Errata Sheet

SLG46140

ISSUE 1: ACMP Output is Inaccurate when using External Vref at High VDD and Temperature Functional Block Affected: ACMP

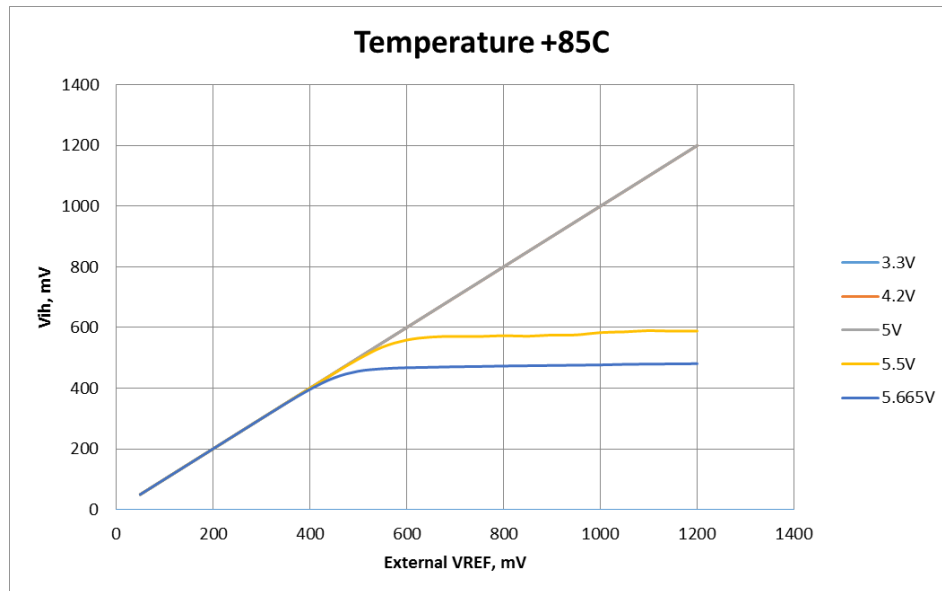
When using external Vref source, the ACMP comparison may happen at wrong threshold if the external Vref voltage is higher than a particular value (please see figure below) at high VDD values ($> 5V$) and high temperature.

Avoid using ACMPs in such conditions.

ISSUE 2: Incorrect Counter Operation after the Reset Functional Block Affected: Counter

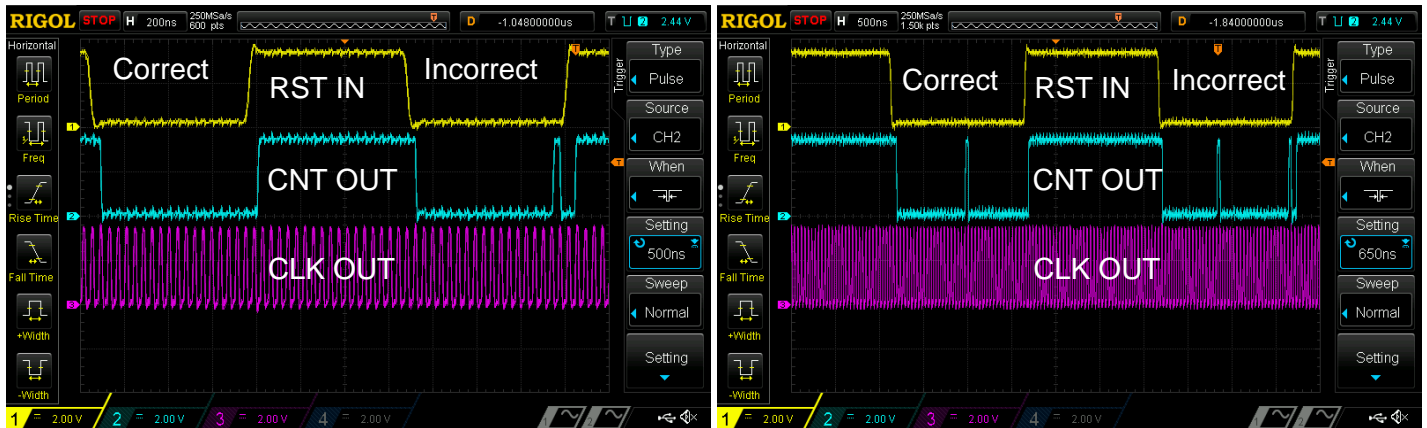
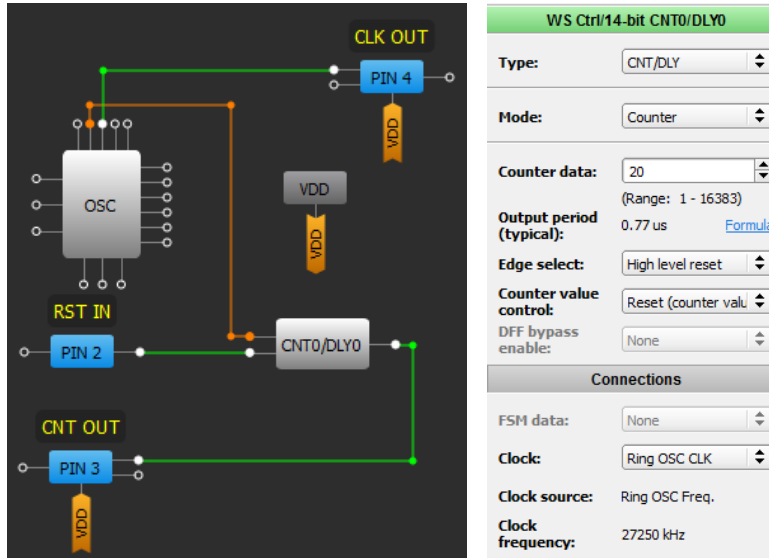
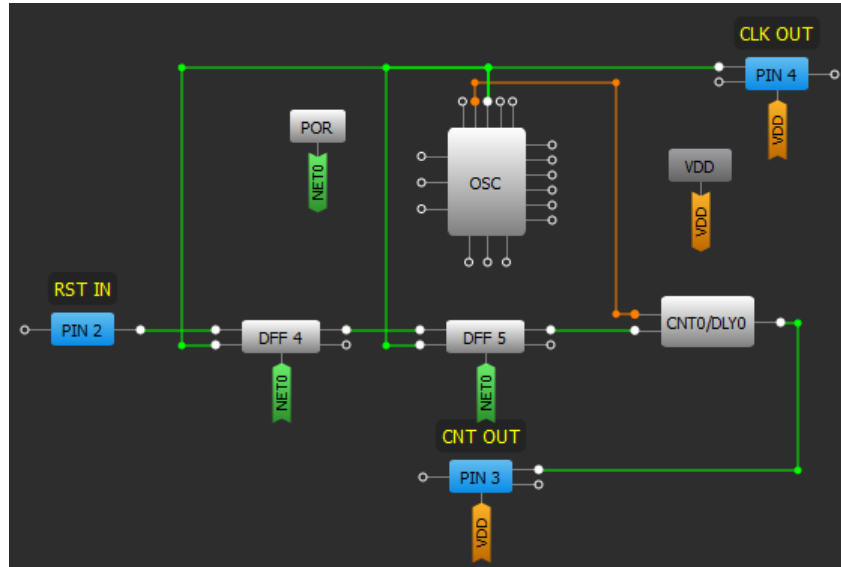
If the Counter Reset occurs at a time very close to a rising edge of the clock signal during clock signal generation (for example OSC operation), there is a possibility that the Counter Data of the Counter is reset incorrectly and the counter end signal (HIGH pulse) may appear faster than expected. This phenomena appears more frequently the higher the clock frequency is.

- Synchronize RESET input of the Counter with its CLK using 2 DFF cells as shown in the image below.

ISSUE 3: DCMP OUT+ Output Glitch
Functional Block Affected: DCMPs

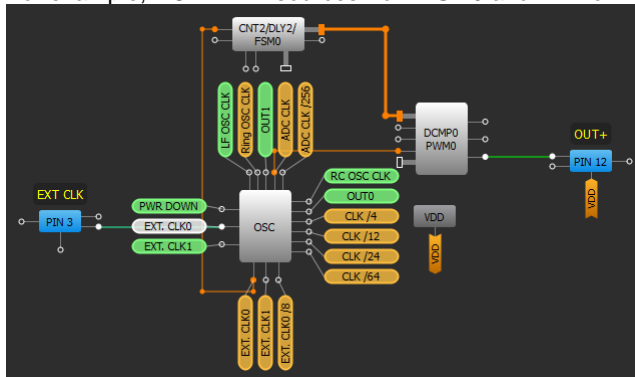
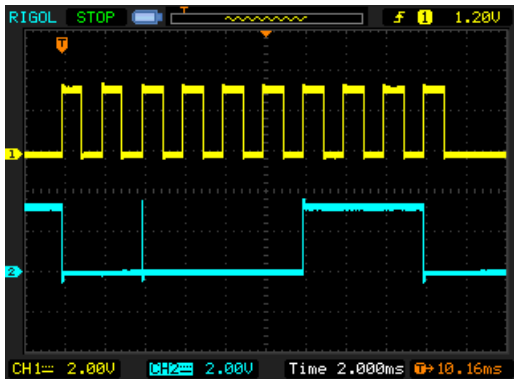
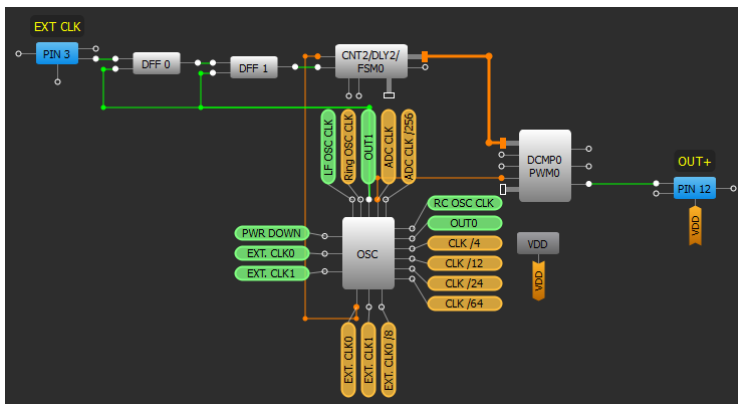
DCMP's OUT+ output may have a glitch when the input data is changed. This issue appears more frequently the higher the DCMP clock is.

For example, DCMP IN+ sources from FSM0 and IN- from Register0. DCMP is clocked from the Ring OSC.

- Synchronize the data source clock with the DCMP clock source using 2 DFF cells as shown in the image below.

ISSUE 6: ACMP Output Glitch due to Ring OSC Operation

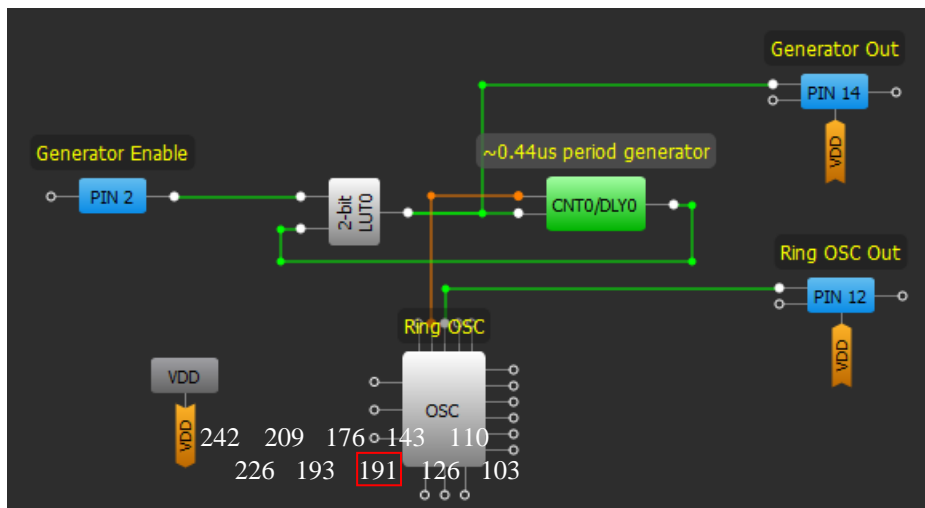
The output of the ACMP incorrectly goes low even when IN+ is greater than IN- if the RING OSC is active when the WS signal rises

- Avoid using the RING OSC with the WS Controller, or add a filtering block on the ACMP output to filter out the glitch.

ISSUE 7: Long Ring OSC Settling Time

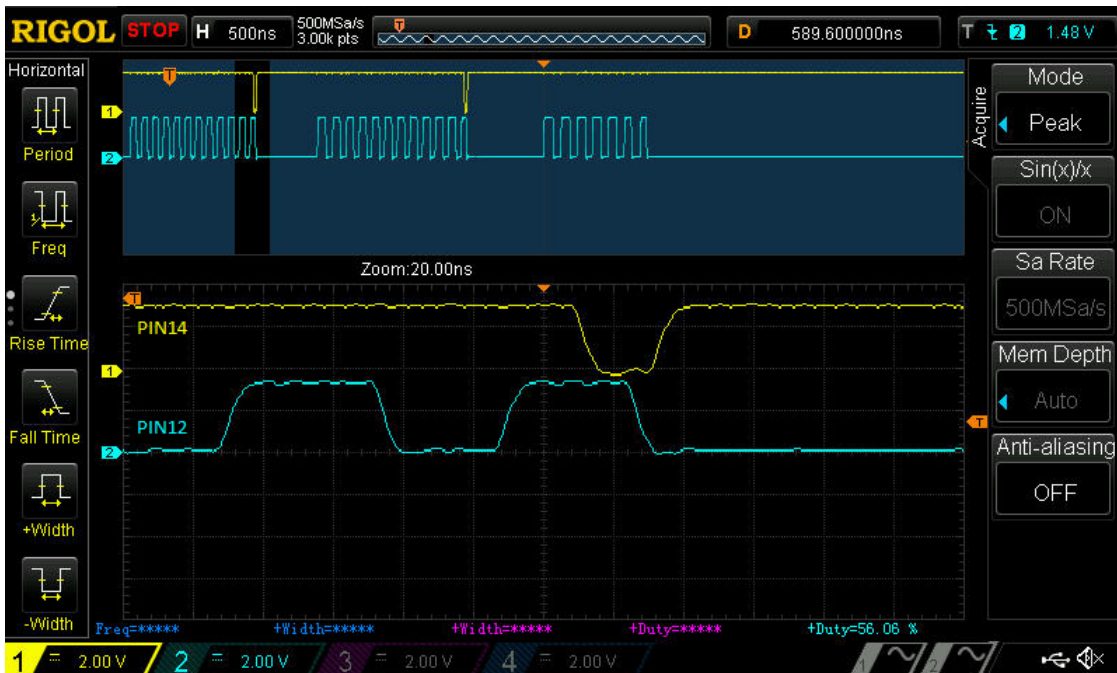
The Ring OSC has a longer settling time when configured as Auto Power On in the designs that have very short Ring OSC disable time. An example of such issue is in the following configuration:

The configuration shown above generates a periodical signal with a frequency defined by the Delay cell and started by a high signal on PIN2. The issue becomes apparent in a longer settling time when the scheme generates short pulses (Delay is configured as a rising edge delay only). See waveform below.

- Set Ring OSC power mode to “Force Power On”
- or, Set Turn on by register option in BG (Band Gap) block as “Enable”

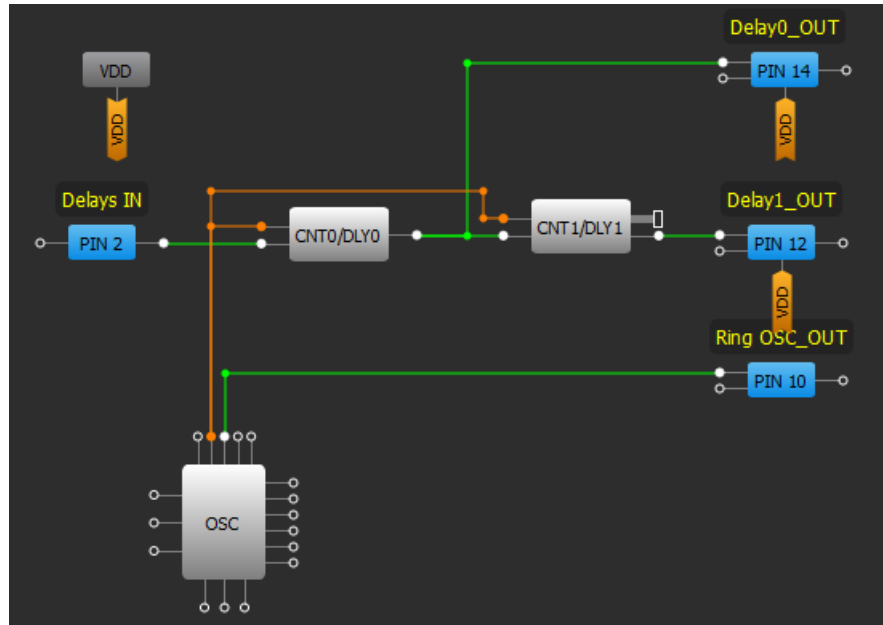
A similar situation occur while using two connected delays (all edge detect types except for a pair “Rising edge DLY – Falling edge DLY”).

In the following example, Delay0 and Delay1 are configured in the same way. However, Delay0 time is 11.4us instead of expected 0.4us (Delay0 time).
